NEDO-24154-A
78NED290R1
CLASS I
AUGUST 1986

LICENSING TOPICAL REPORT

QUALIFICATION OF THE ONE-DIMENSIONAL CORE TRANSIENT MODEL FOR BOILING WATER REACTORS VOLUME 1

Docket No. 50-271 Official Exhibit No. Entergy 26

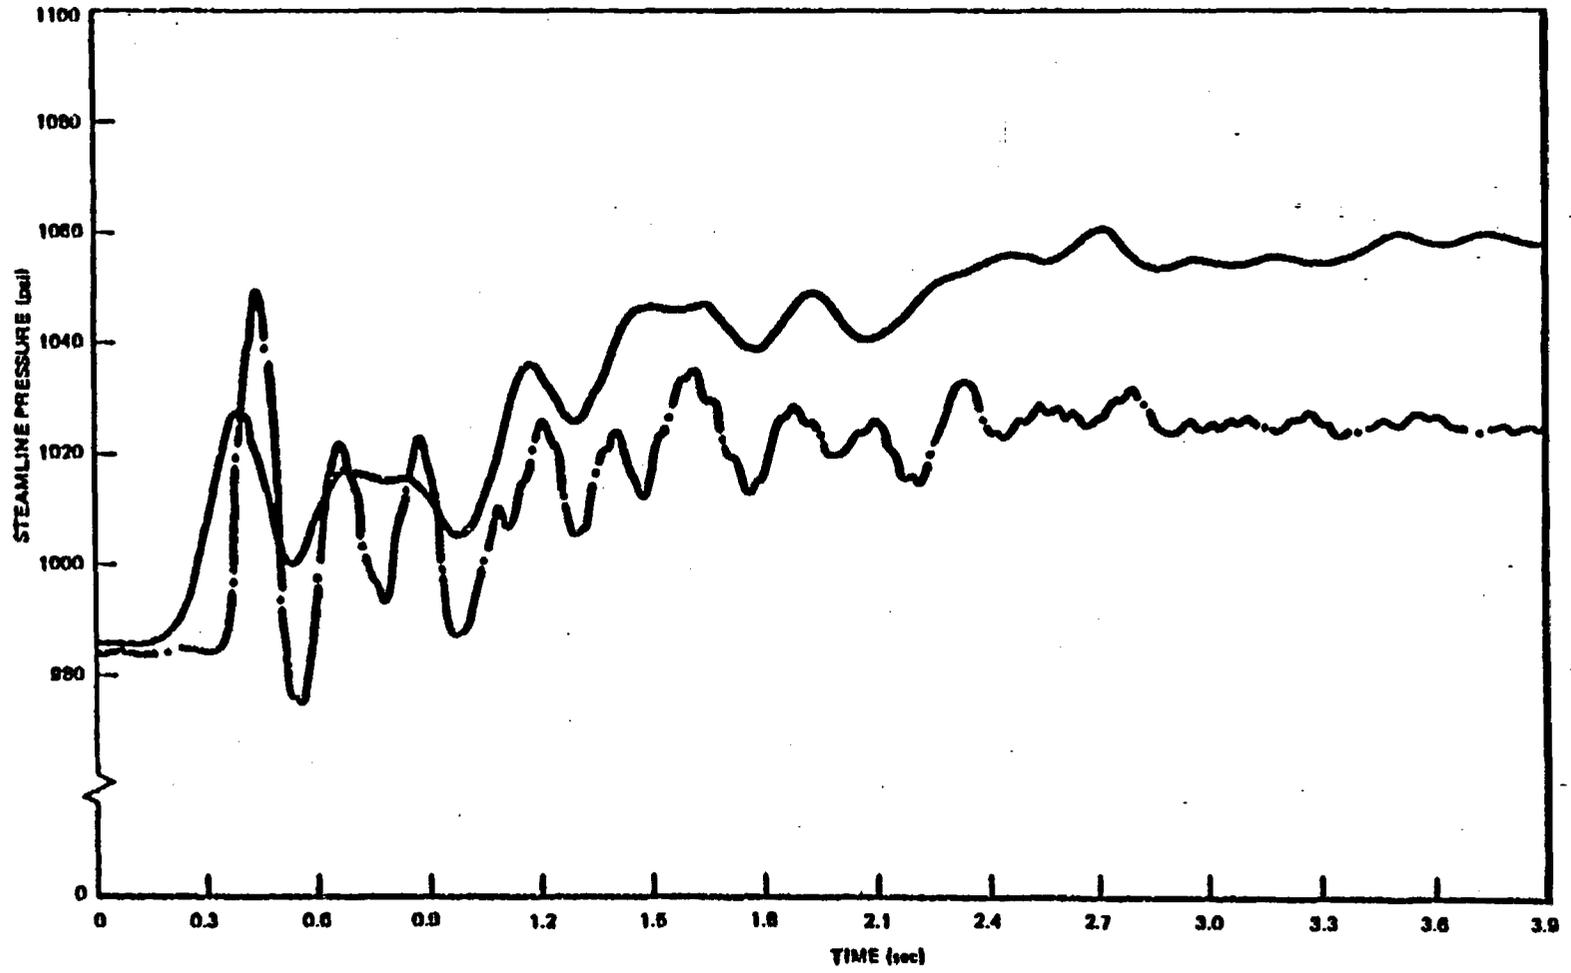
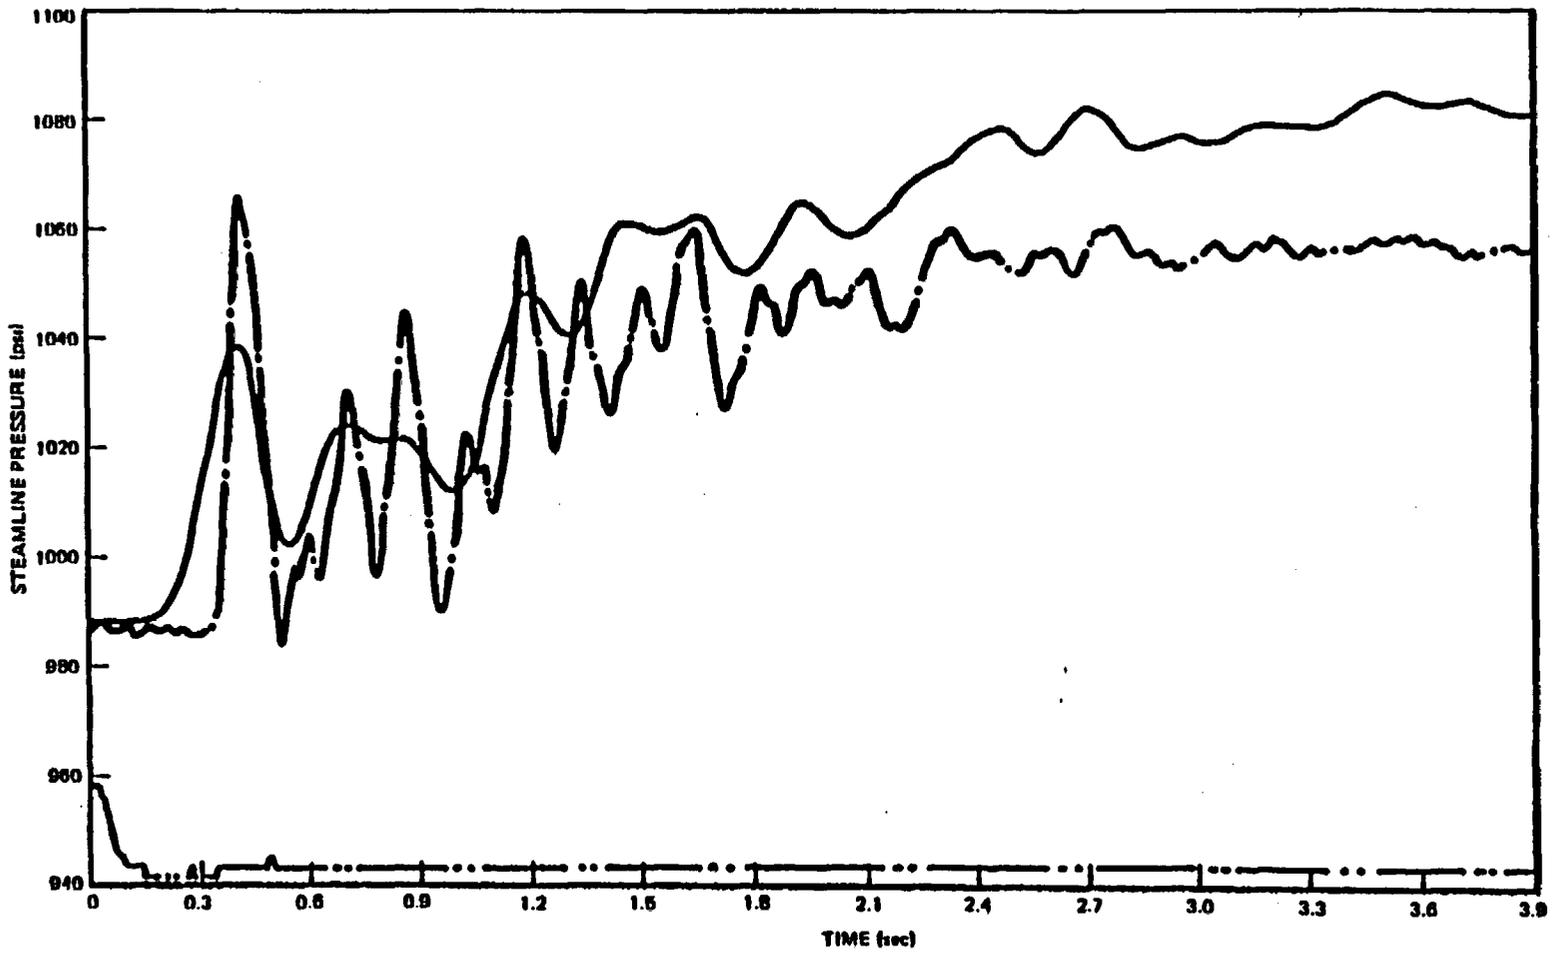
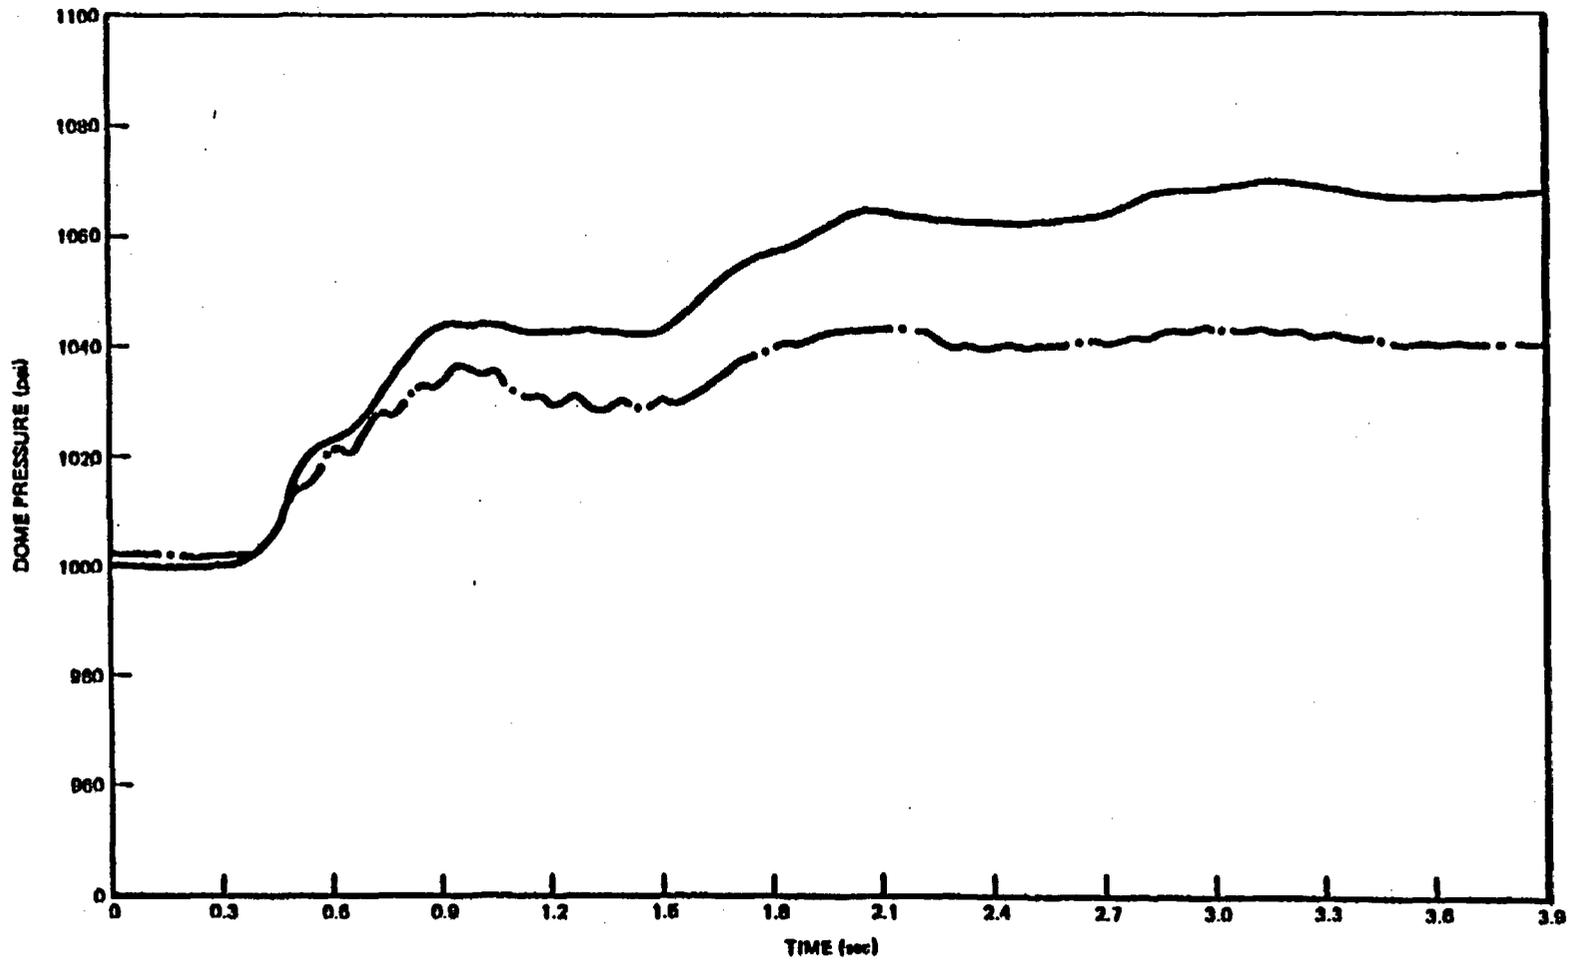
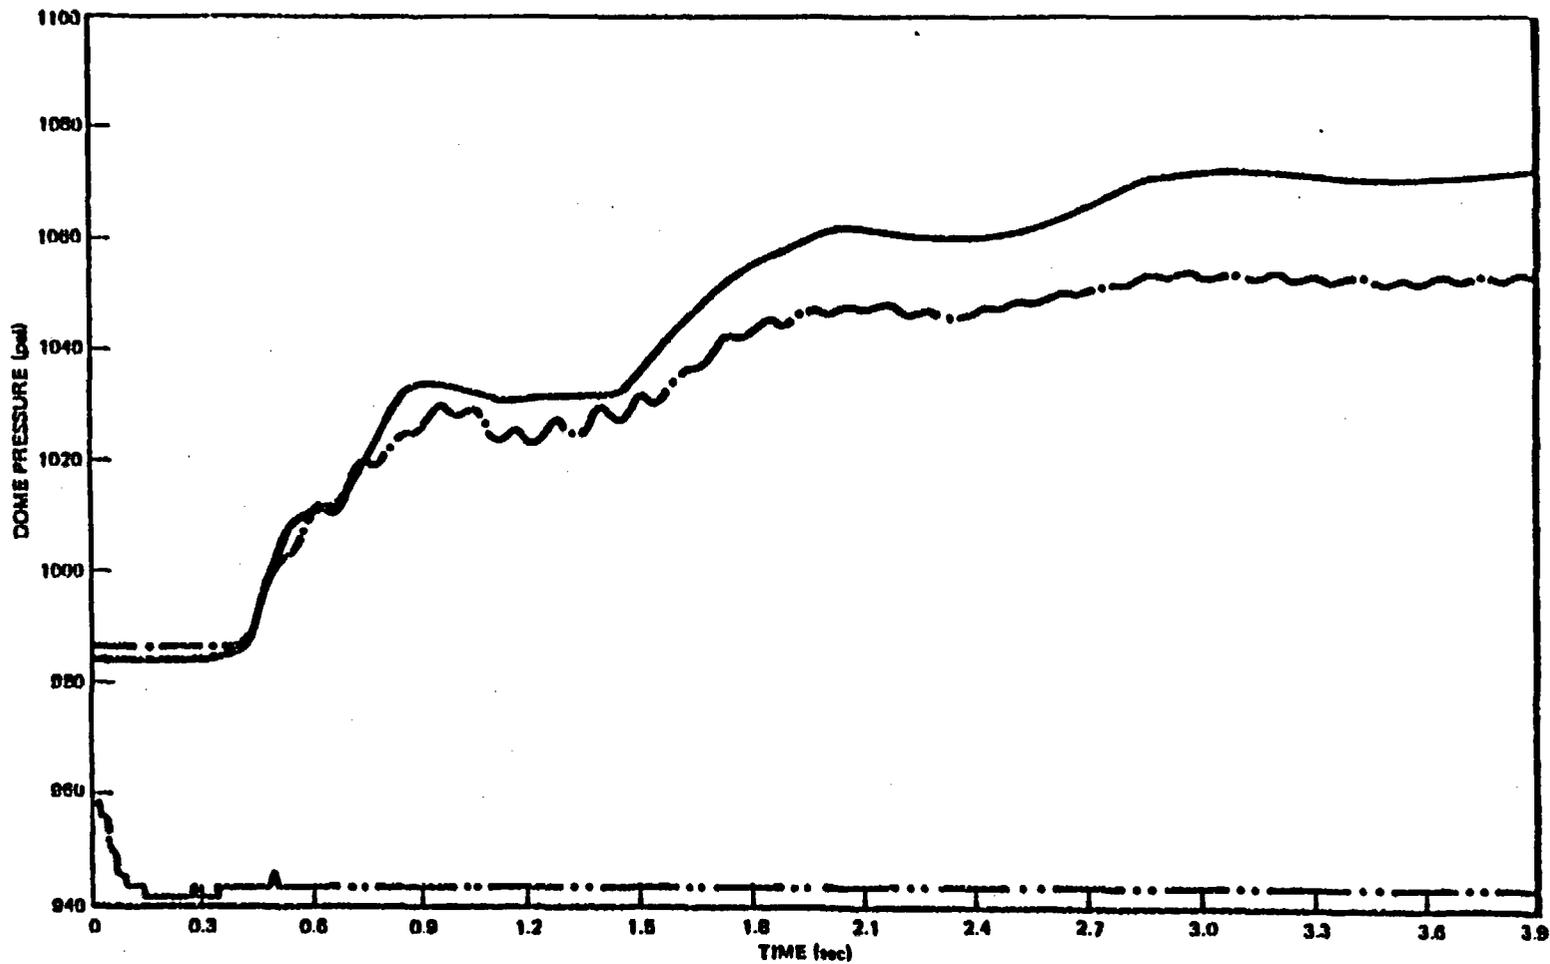
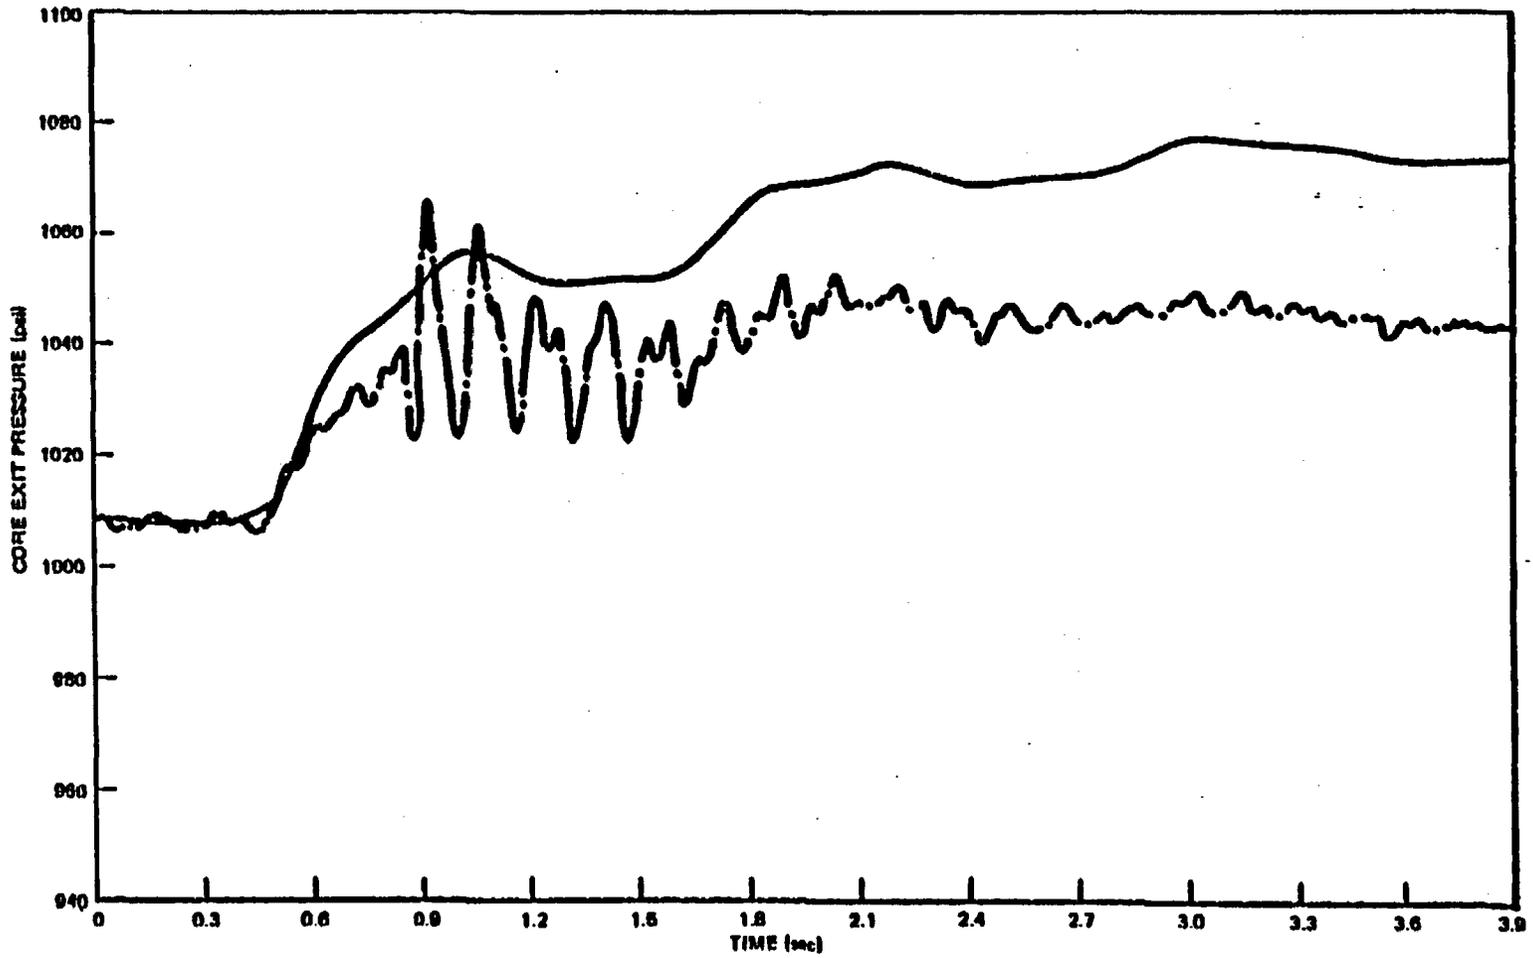
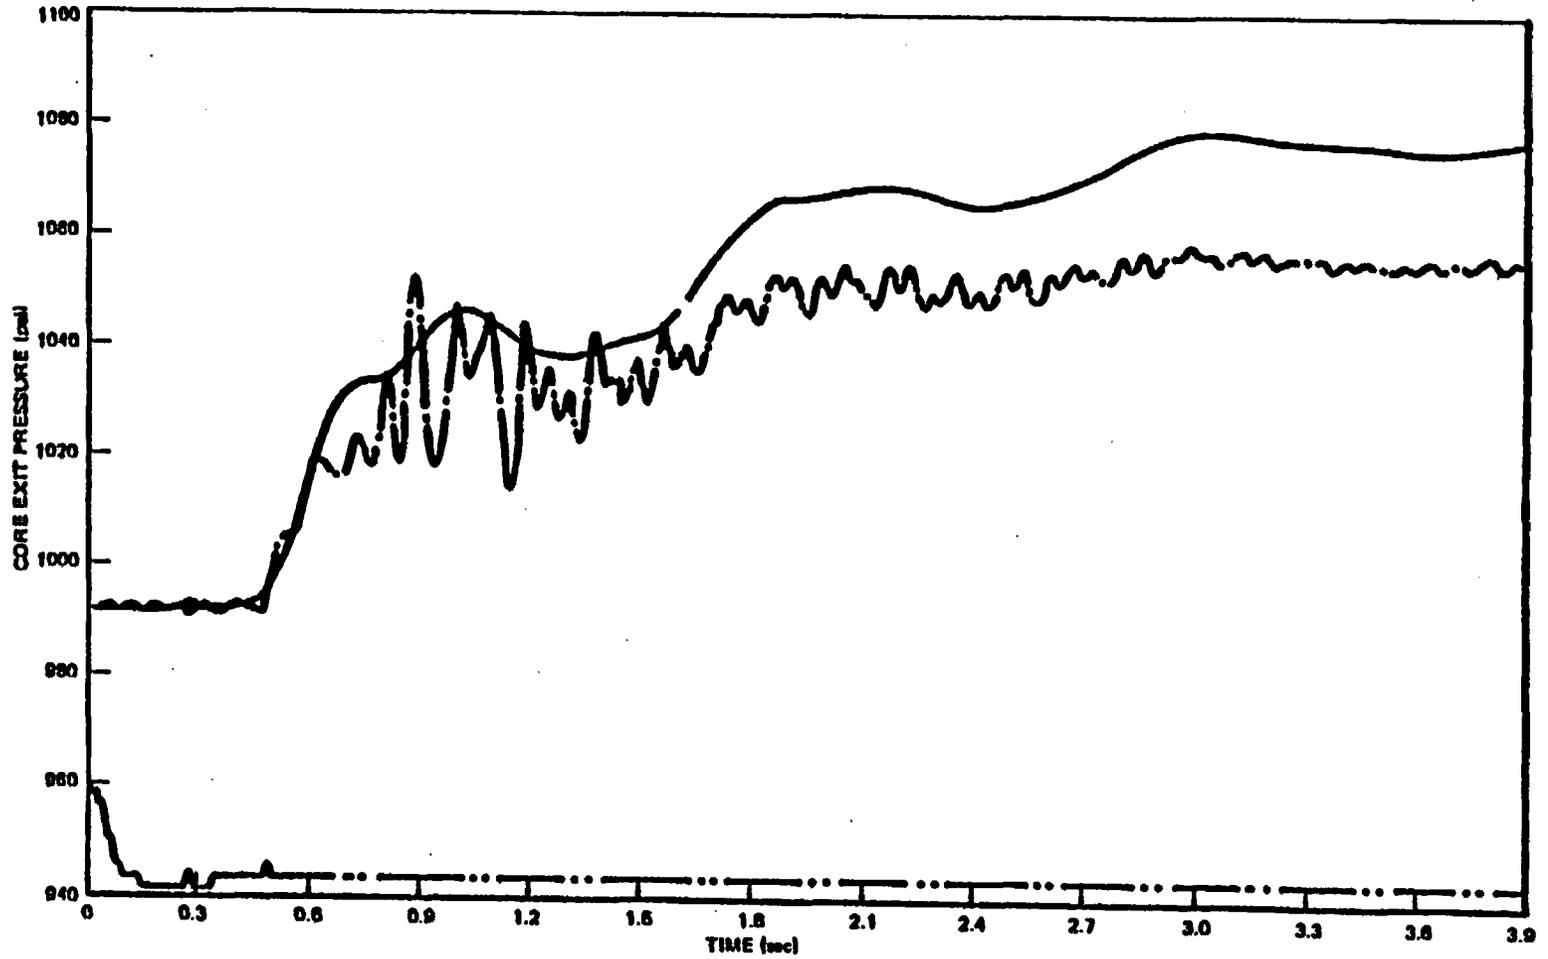
Extend the pressure plots of Figure 3-6 through 3-14 and 3-40 through 3-45 through a period of 3.0 sec to include the peak pressure region both for Peach Bottom and KKM tests.

Figures 3-6 through 3-14 and 3-40 through 3-45 have been modified to include in excess of 3.0 sec in the qualification documentation.

Figure 4-13. Valve Flow Control Block Diagram

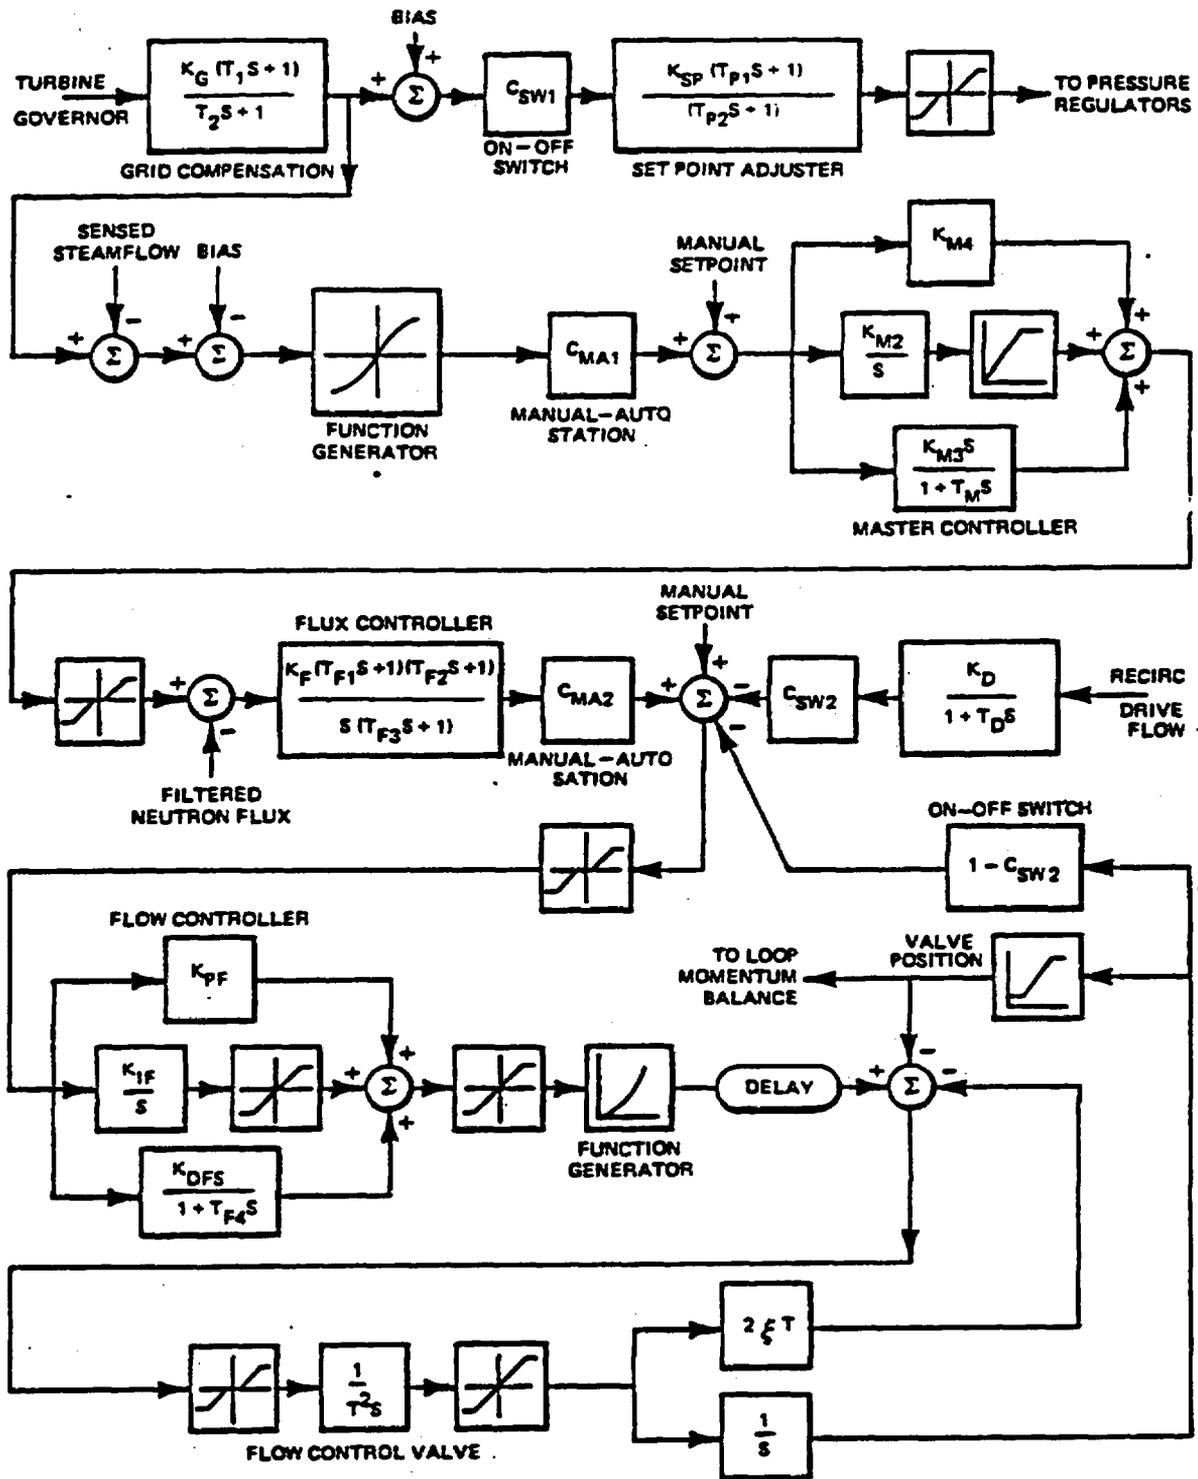
Figure 4-13 provides a block diagram of the valve flow control. Additional description of the control system is required to complete our review of the block diagram. In this regard, provide the following information:

The block entitled, "Grid Compensation Function" in the block diagram (Figure 4-13) is a lead/lag function, the time constants of which are approximately the inverse of the lag/lead function in the pressure regulator. Its purpose is to give the load following loop lead effect to compensate for the lag effect inherent in the pressure regulator. Gain K_G is determined by calculation and verified experimentally both in the field and on the computer.
